## DESCRIPTIVE REPORT

*Registry No.* ..... H-11273

*Sublocality* ..... Approaches to Port Clarence

## Revisions Compiled During Office Processing

Figure 2. The junction locations of H-11273 and H-11274

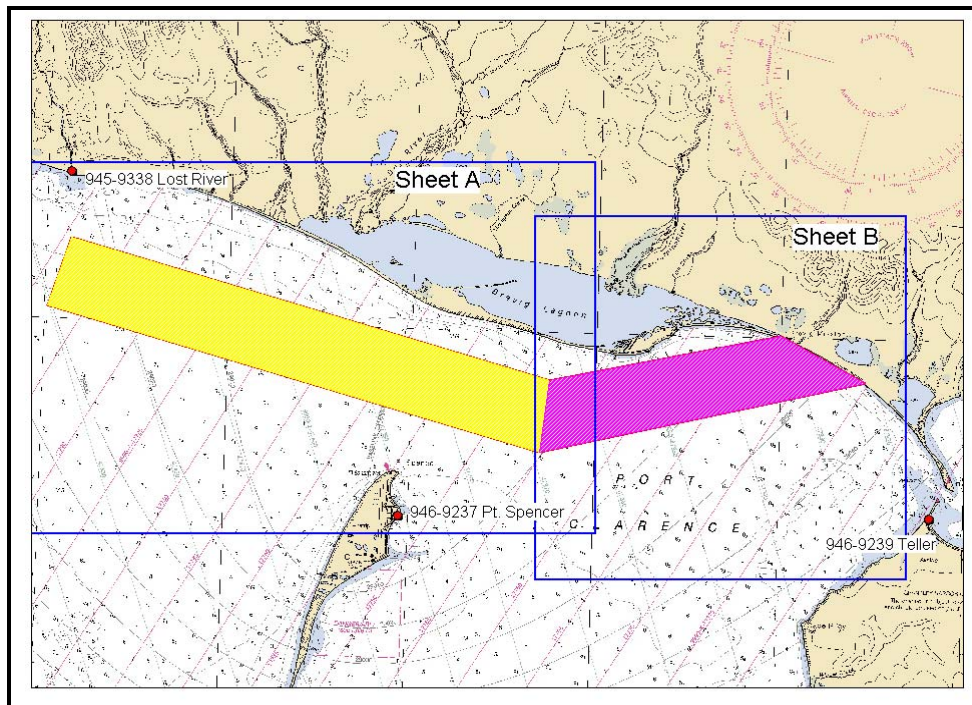
The easterly limits of this survey junctions<sup>13</sup> the westerly limits of H-11274 (2005, Scale 1:20,000) (see *Figure 2*). There was good agreement between the soundings from each survey.<sup>14</sup>

<sup>14</sup> Concur. Soundings within the junction area of H11273 and H11274 agreed to within 0.1 fathom or less.

*Smooth sheet H-11273 overlaid on Chart 16204 6<sup>th</sup> Ed. for comparison*

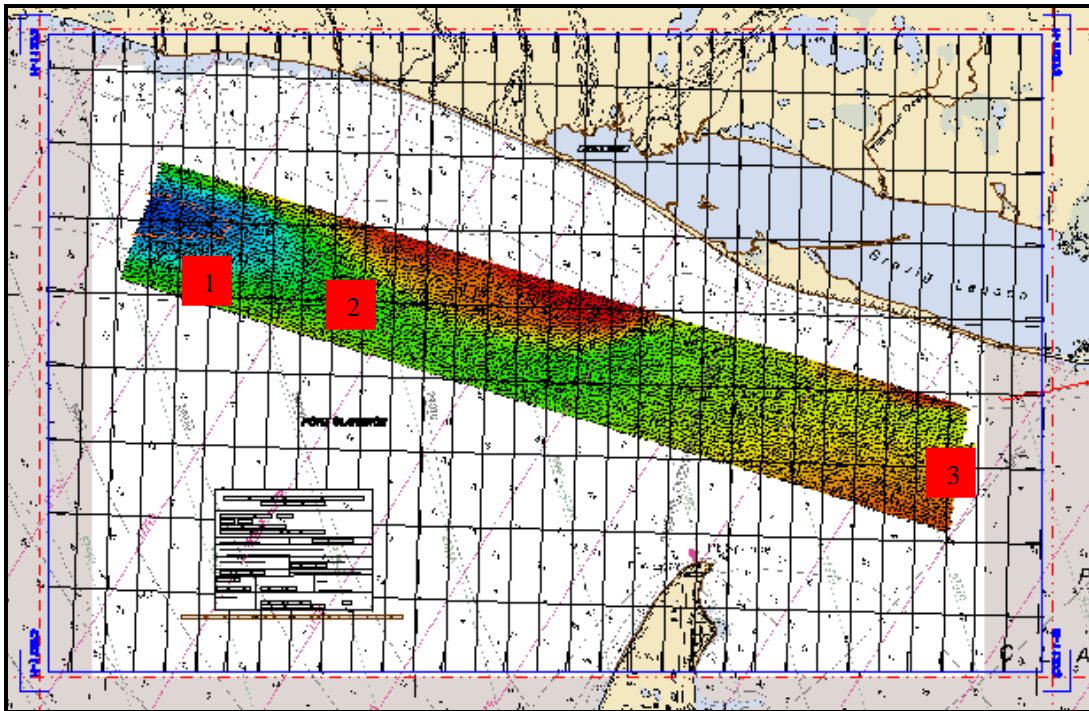
This survey generally agrees well with the chart.<sup>23</sup> The following pages contain the depth discrepancies found on the smooth sheet.

<sup>23</sup> Concur with clarification. An error in shoreline digitization on the smooth sheet resulted in smooth sheet misalignment of roughly 130-150 meters off the raster grid for the chart comparison, as can be seen from the chartlets on the following pages. Discussion with the hydrographer confirmed the misalignment in the chart comparison. However, this error did not affect the data. A corrected chart comparison in PHB during office processing showed a general shoaling trend of 1-4 feet throughout the survey area with Chart 16204, 6<sup>th</sup> Edition, continuous maintenance raster dated 4/1/08. Details are discussed in the following endnotes.

Area 1

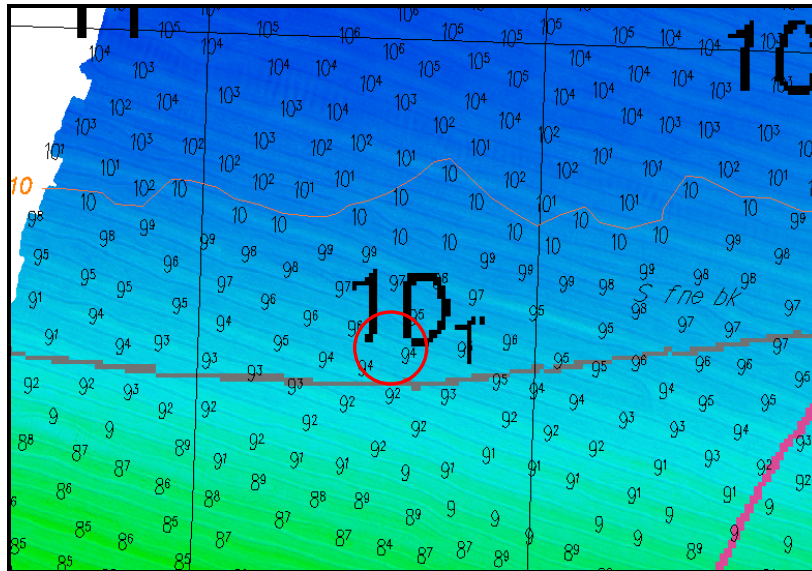
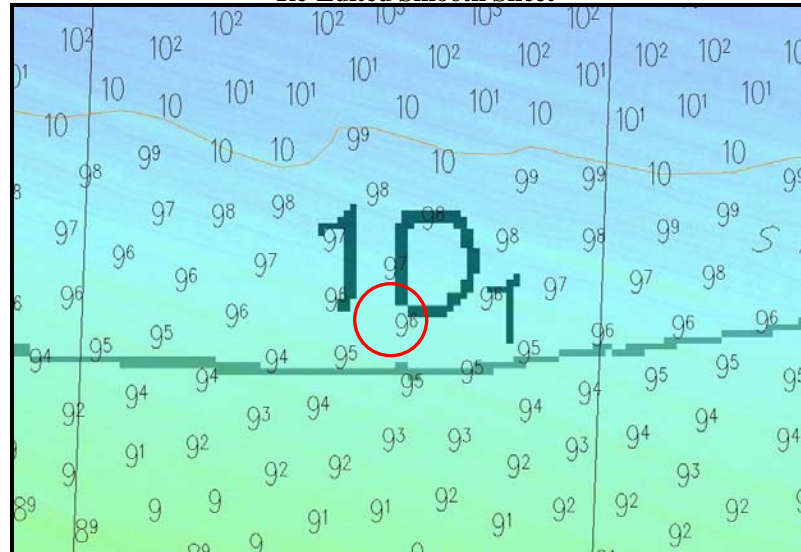
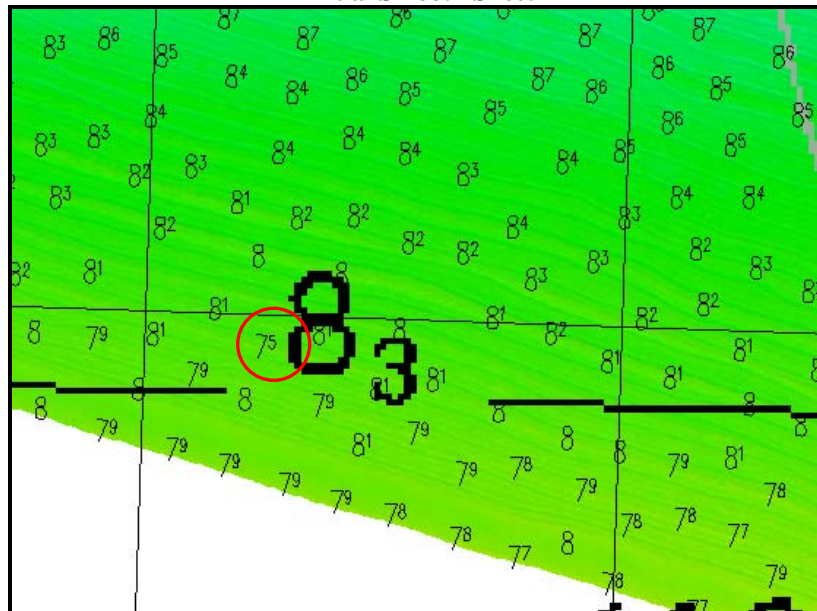
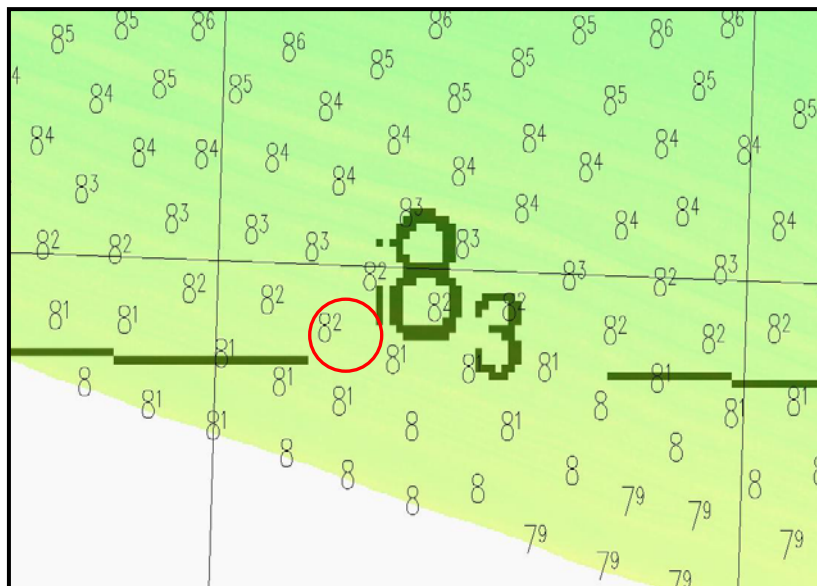
In the vicinity of Latitude N 65° 20' 36" Longitude W 167° 08' 23", 2005 soundings were initially reported as shoaler than charted soundings by up to 4.6 feet. After re-editing, these soundings are shoaler than charted soundings by up to 3.4 feet.<sup>26</sup> The hydrographer recommends updating the next chart edition with soundings from the re-edited 2005 survey.<sup>27</sup>

In the vicinity of Latitude N 65° 19' 58" Longitude W 167° 06' 45", 2005 soundings were initially reported as shoaler than charted soundings by up to 6 feet. After re-editing, these soundings remain shoaler than charted soundings by up to 1.8 feet.<sup>28</sup> The hydrographer recommends updating the next chart edition with soundings from the re-edited 2005 survey.<sup>29</sup>

<sup>26</sup> The charted sounding of 10 fm 1 ft is at approximately Latitude N 65° 20' 44" Longitude W 167° 08' 23". After smooth sheet repositioning, the shoalest survey sounding in the vicinity is 9 fm 4 ft, approximately 3 feet shoaler than charted. Chart according to the smooth sheet.

<sup>28</sup> The charted sounding of 8 fm 3 ft is at approximately Latitude N 65° 20' 04" Longitude W 167° 06' 38". After smooth sheet repositioning, the shoalest survey

sounding in the vicinity is 8 fm 2 ft, approximately 1 foot shoaler than charted. Chart according to the smooth sheet.

Area 2

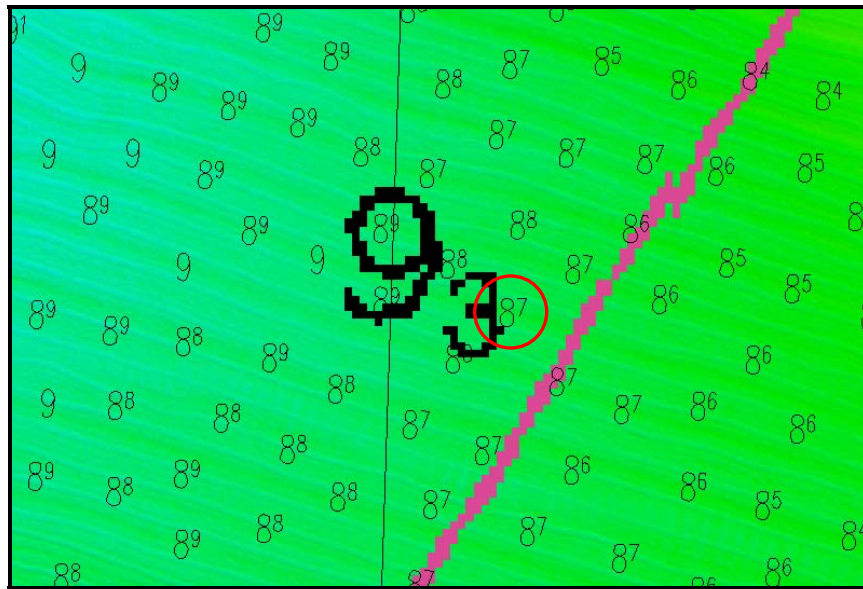
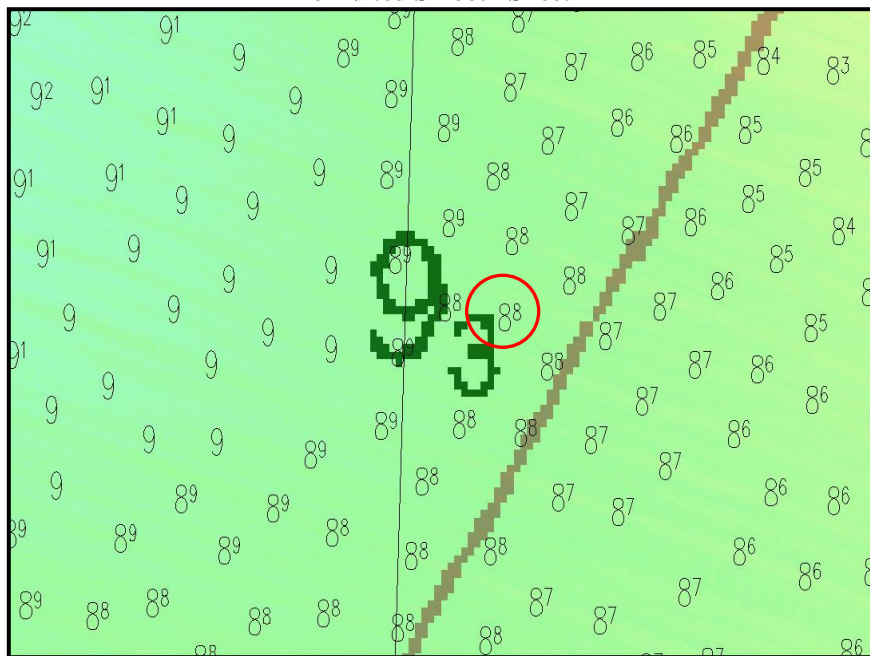
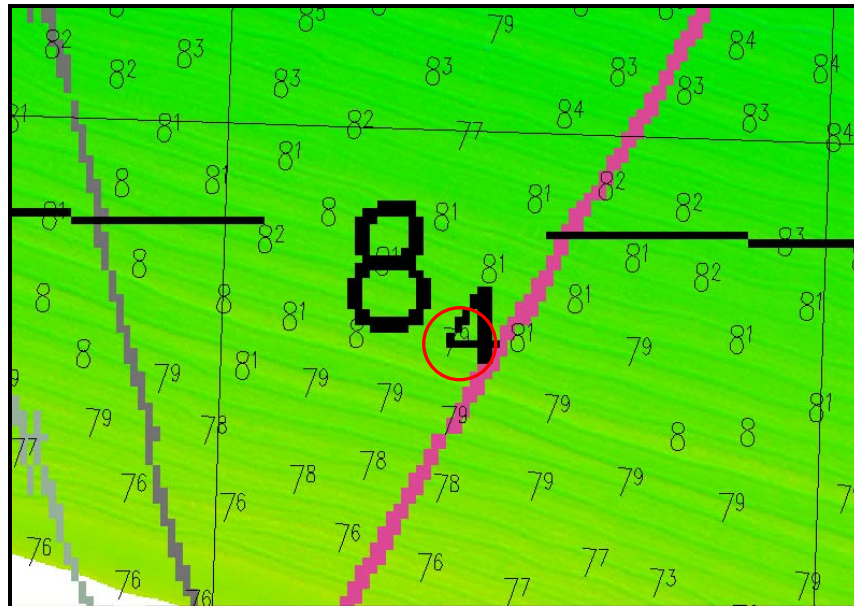
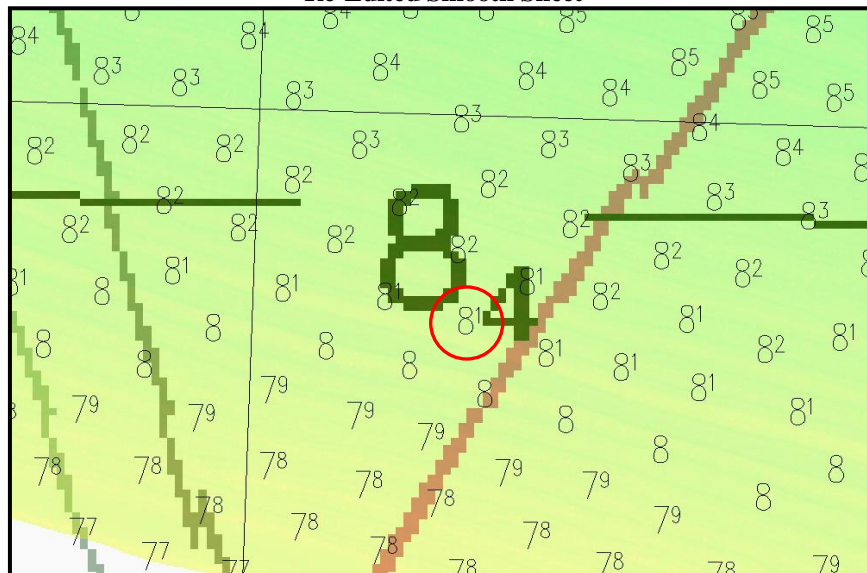
In the vicinity of Latitude N 65° 20' 29" Longitude W 167° 03' 48", 2005 soundings were initially reported as shoaler than charted soundings by up to 4.8 feet. After re-editing, these soundings are shoaler than charted soundings by up to 4.2 feet.<sup>30</sup> The hydrographer recommends updating the next chart edition with soundings from the re-edited 2005 survey.<sup>31</sup>

In the vicinity of Latitude N 65° 19' 51" Longitude W 167° 04' 37", 2005 soundings were initially reported as shoaler than charted soundings by up to 4.6 feet. After re-editing, these soundings are shoaler than charted soundings by up to 3.4 feet.<sup>32</sup> The hydrographer recommends updating the next chart edition with soundings from the re-edited 2005 survey.<sup>33</sup>

<sup>30</sup> The charted sounding of 9 fm 3 ft is at approximately Latitude N 65° 20' 36" Longitude W 167° 04' 00". After smooth sheet repositioning, the shoalest survey sounding in the vicinity is 8 fm 8 ft, approximately 4 feet shoaler than charted. Chart according to the smooth sheet.

<sup>32</sup> The charted sounding of 8 fm 4 ft is at approximately Latitude N 65° 19' 59" Longitude W 167° 04' 45". After smooth sheet repositioning, the shoalest survey sounding in the vicinity is 8 fm 3 ft, approximately 1 foot shoaler than charted. Chart according to the smooth sheet.

**Area 3**

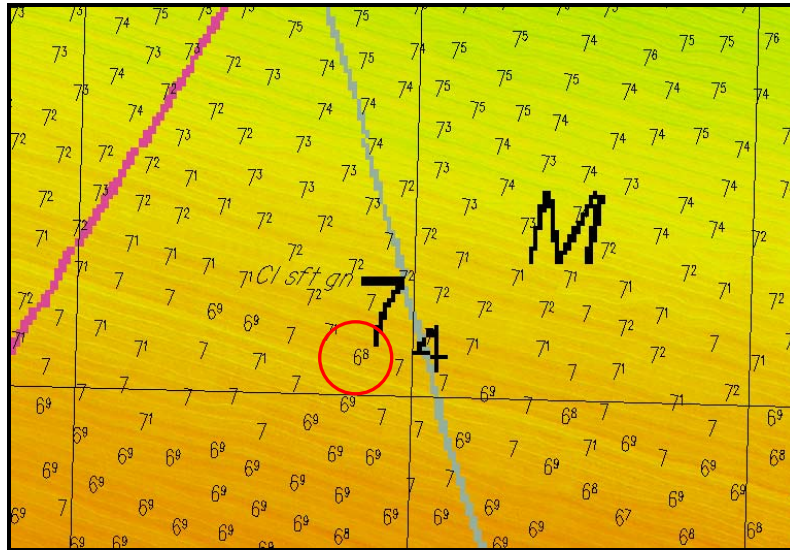
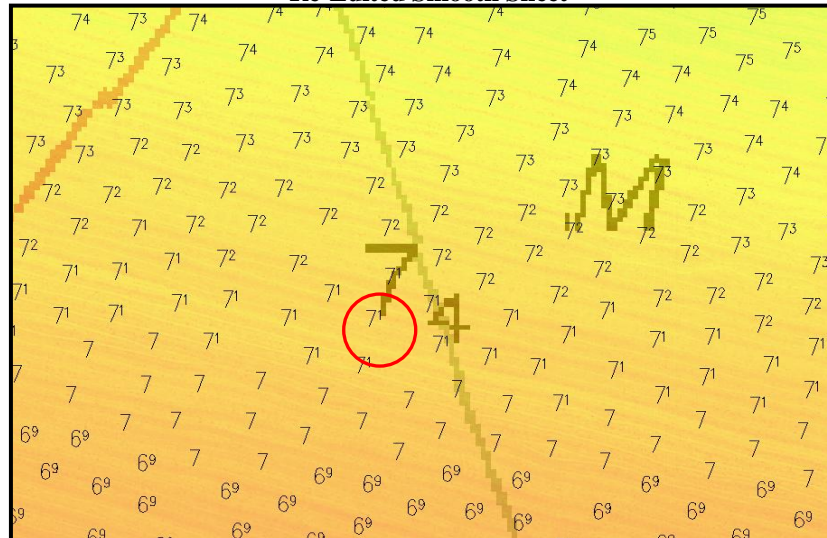
In the vicinity of Latitude N 65° 18' 02" Longitude W 166° 44' 09", 2005 soundings were initially reported as shoaler than charted soundings by up to 5.2 feet. After re-editing, these soundings are shoaler than charted soundings by up to 3.4 feet.<sup>34</sup> The hydrographer recommends updating the next chart edition with soundings from the re-edited 2005 survey.<sup>35</sup>

<sup>34</sup> The charted sounding of 7 fm 4 ft is at approximately Latitude N 65° 18' 11" Longitude W 166° 44' 06". After smooth sheet repositioning, the shoalest survey sounding in the vicinity is 7 fm 2 ft, approximately 2 feet shoaler than charted. Chart according to the smooth sheet.

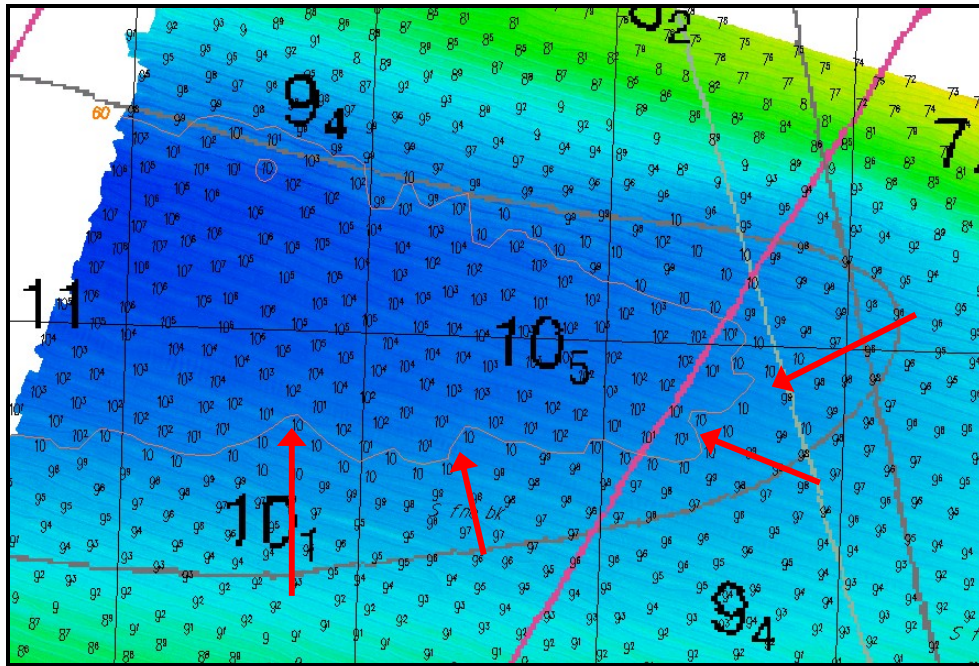
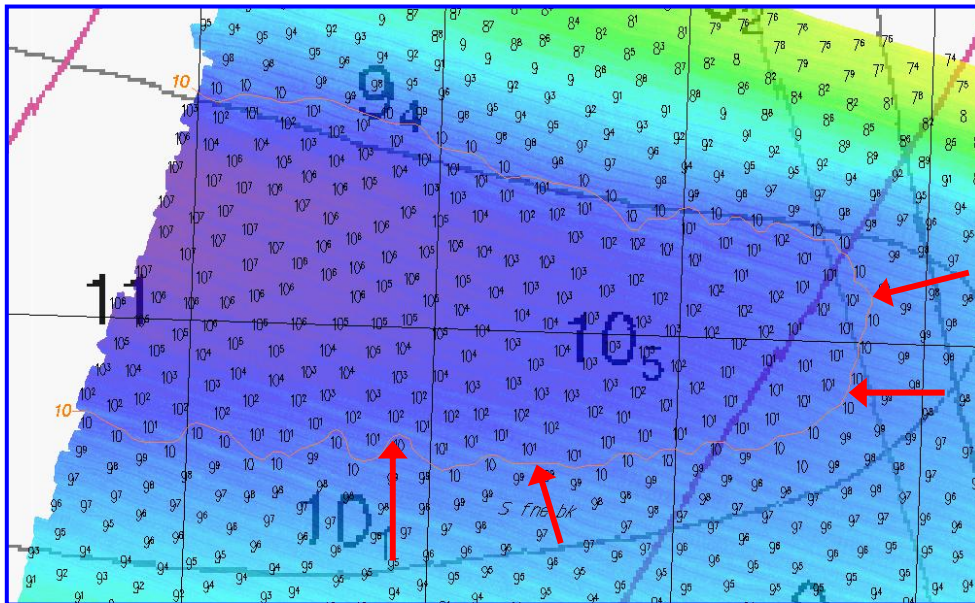
In the vicinity of Latitude N 65° 20' 57" and Longitude W 167° 06' 18" initial smooth sheet soundings show the east end of the 10 fathom contour has migrated westward by as much as 350 meters.<sup>38</sup> The south side of the 10 fathom contour has migrated northward by as much as 450 meters.<sup>39</sup> After re-editing, this trend continues. The hydrographer recommends updating the next chart edition by using the contours from the re-edited 2005 survey.<sup>40</sup>

<sup>38</sup> Concur.

<sup>39</sup> The corrected chart comparison shows maximum northward movement of the 10 fm curve to be approximately 330 m. Chart as shown on the smooth sheet.

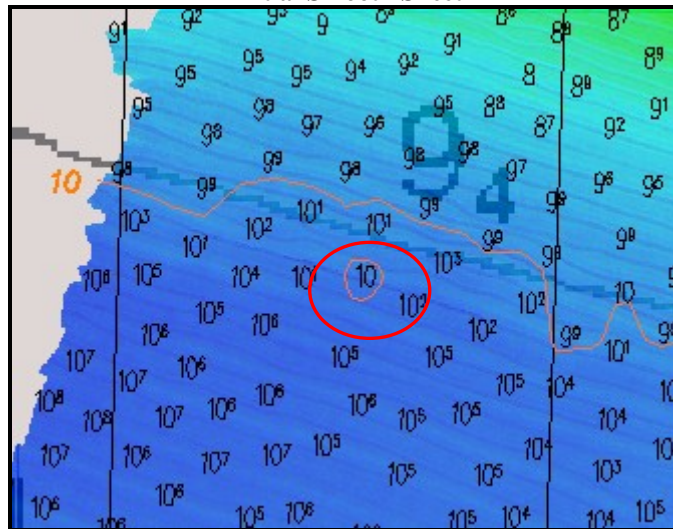
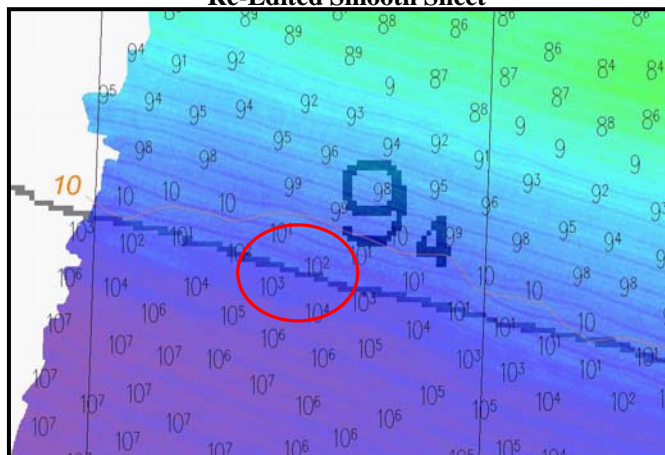
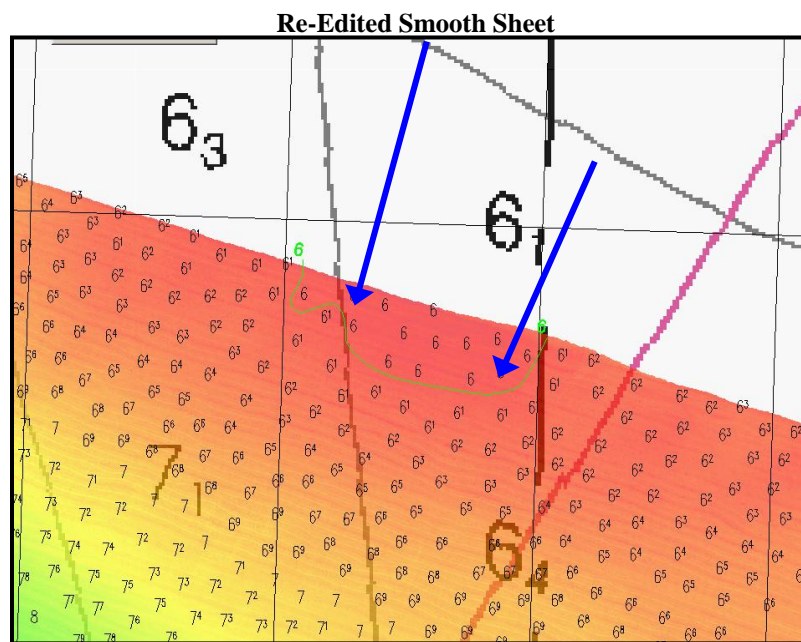
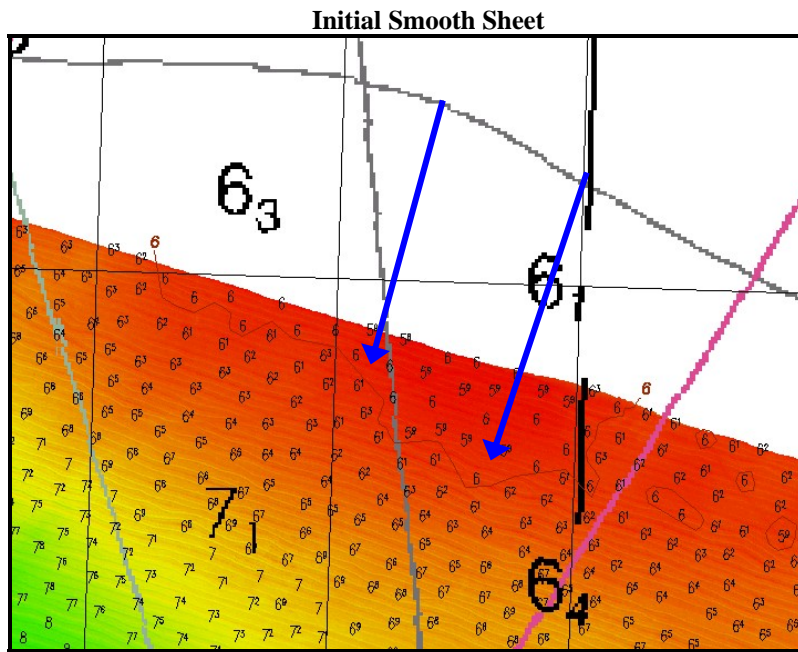
In the vicinity of Latitude N 65° 21' 17" and Longitude W 167° 08' 26", initial smooth sheet soundings show a ten fathom contour not previously charted. After re-editing, this contour no longer exists. The hydrographer does not recommend adding a ten fathom contour in this area.<sup>41</sup>

In the vicinity of Latitude N 65° 20' 46" and Longitude W 167° 00' 22" initial smooth sheet soundings show the 6 fathom contour has migrated southward by as much as 1000 meters.<sup>42</sup> After re-editing, this trend continues. The hydrographer recommends updating the next chart edition using contours from the re-edited 2005 survey.<sup>43</sup>

<sup>41</sup> Concur. Chart as shown on the smooth sheet.

<sup>42</sup> Concur with clarification. Since the area north of approximately Lat 65/20/56 N, Lon 167/0/55 W to the charted 6 fm curve at Lat 65/21/24 N was not included in survey H11273, it is unknown whether the 6 fm curve has moved or the survey found a new, isolated 6 fm curve. Retain unsurveyed area as charted and chart new 6 fm curve as shown on the Hdrawing.
